**PLANNED UNIT DEVELOPMENT
& SUBDIVISION STAFF REPORT****Date: January 15, 2015**

<u>DEVELOPMENT NAME</u>	Springhill Memorial Subdivision, Resubdivision of Lot A
<u>SUBDIVISION NAME</u>	Springhill Memorial Subdivision, Resubdivision of Lot A
<u>LOCATION</u>	3719 Dauphin Street (South side of Dauphin Street at West I-65 Service Road South)
<u>CITY COUNCIL DISTRICT</u>	District 5
<u>AREA OF PROPERTY</u>	2 Lots / 10.9 ± acres (Subdivision) 7 Lots / 37.2 ± acres (Planned Unit Development)
<u>CONTEMPLATED USE</u>	Planned Unit Development Approval to amend a previously approved Planned Unit Development to allow multiple buildings on a single building site, and Subdivision approval to create 2 lots.
<u>TIME SCHEDULE FOR DEVELOPMENT</u>	Not specified
<u>ENGINEERING COMMENTS</u>

SITE PLAN

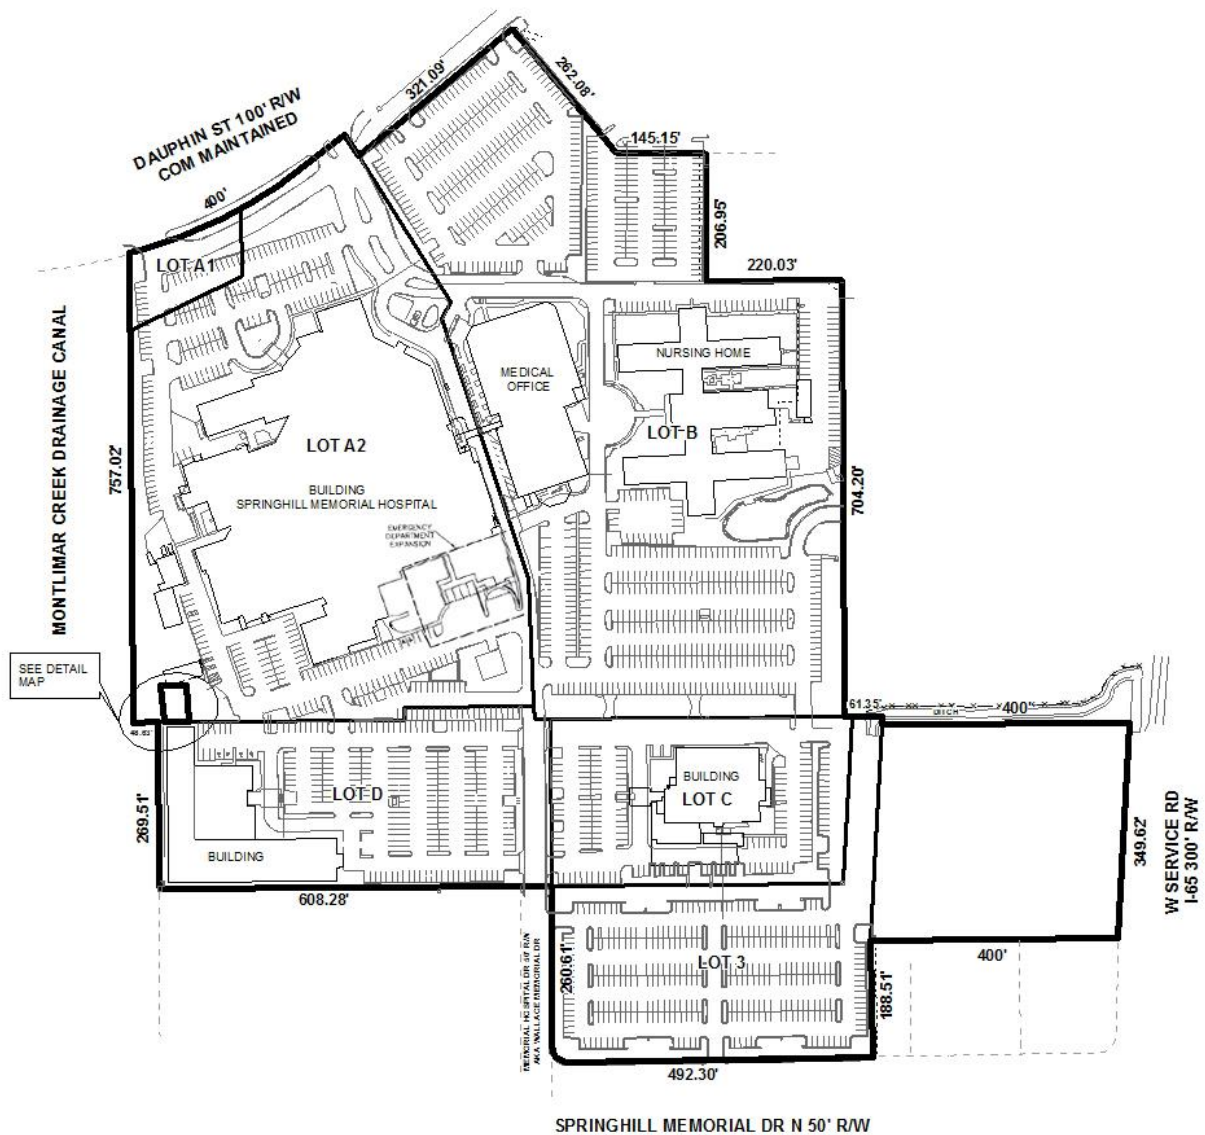
It should be noted that the PUD site plan does not include the entirety of the Orthopedic Center Subdivision lot, recorded in Map Book 101, Page 99. Therefore the site plan should be revised to depict the entirety of the lot and associated improvements.

Dumpsters are not clearly depicted on the site plan. If any new dumpsters are placed on the overall PUD site, or if existing dumpsters are relocated, they must comply with the enclosure and sanitary sewer connection requirements of Section 64-4.D.9. of the Zoning Ordinance.

- 2) Revision of the PUD site plan parking calculations to include the loss of parking spaces due to the emergency room area modifications, and the additional parking provided via condition number 1;

- 1) Revision of the PUD site plan to include the entirety of the Orthopedic Center Subdivision lot, recorded in Map Book 101, Page 99, including the associated parking and landscape areas;
